[Issue No.] GOT-A-0138
[Title] Compatibility Between GT Designer3 (GOT2000) Version and GT2103-PMBD
    Hardware Version
[Date of Issue] May 2019
[Relevant Models] GOT2000 series

1. Models affected
GT2103-PMBD
(GOT2000 series 3.8" GT21 model with built-in Ethernet and RS422/485 interfaces)

■1. Rating plate on the GOT rear face
Check the rating plate on the GOT for its hardware version.

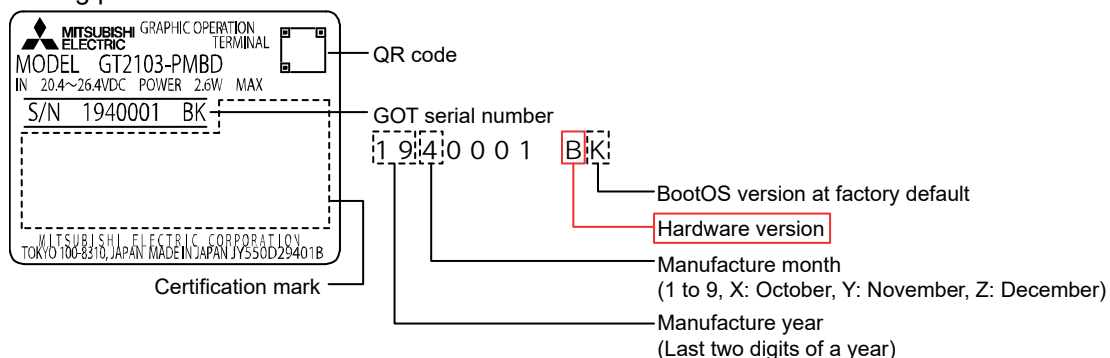
2. Details of the change
As the liquid crystal display (LCD) for GT2103-PMBD will be discontinued, the LCD will be changed.
The GT2103-PMBD hardware version will be updated from B to C accordingly.
GT Designer3 (GOT2000) versions earlier than 1.215Z are incompatible with the GOT hardware version C.

Use GT Designer3 (GOT2000) version 1.215Z or later.
